**ENGINEERING CHANGE REQUEST (ECR)**

CUSTOMER DRAWING NO. D 972 475

DRAWING TITLE B9C BELLOW REMOVAL YOKE BAR

REVISION: FROM A TO B

HYTEC, INC	
BSC BELLOWS REMOVAL YOKE BAR	
D972475-1	D 1 of 1

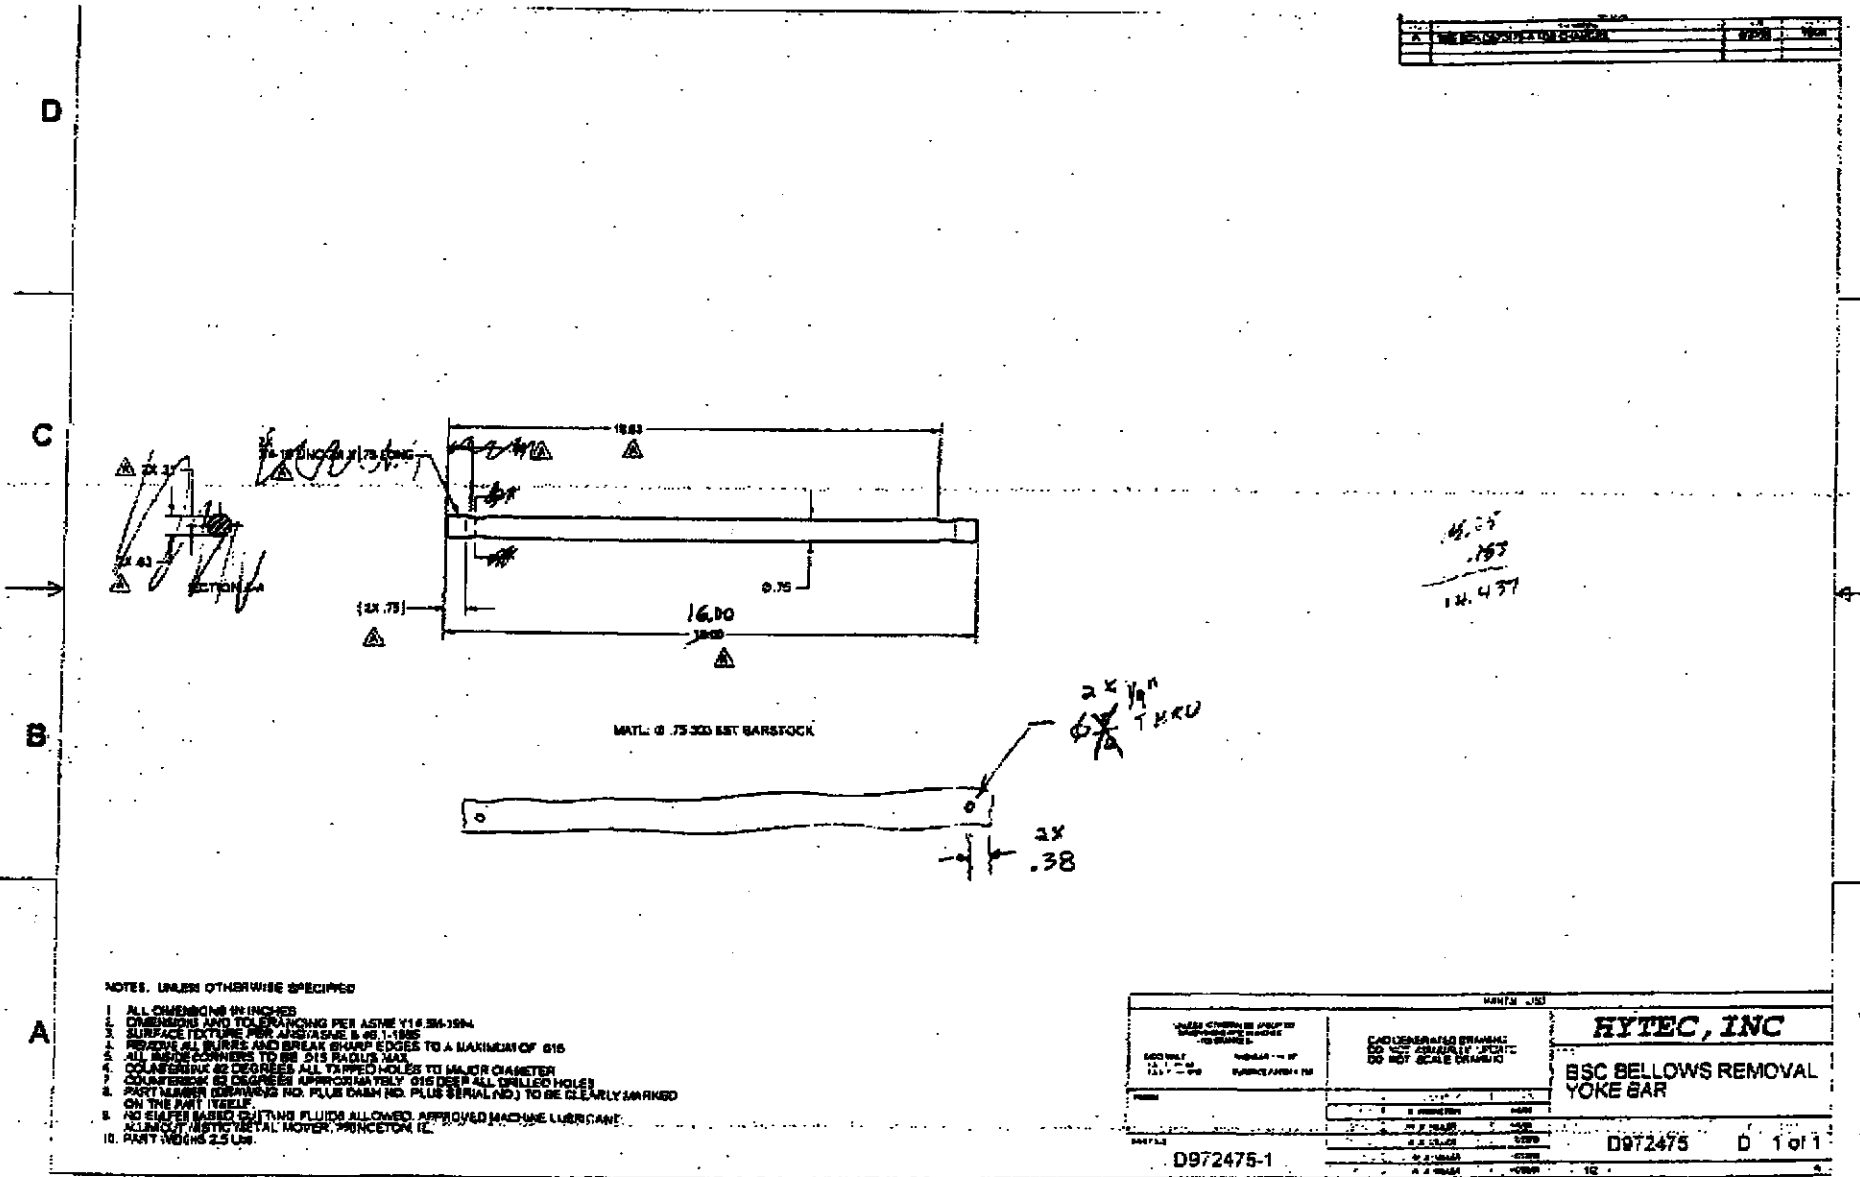
CHANGE TO 16.00 LONG, WITH  $\phi$ .25 HOLE .38" IN FROM  
EACH END (FOR COTTER PIN)  
(ELIMINATE THREADS)
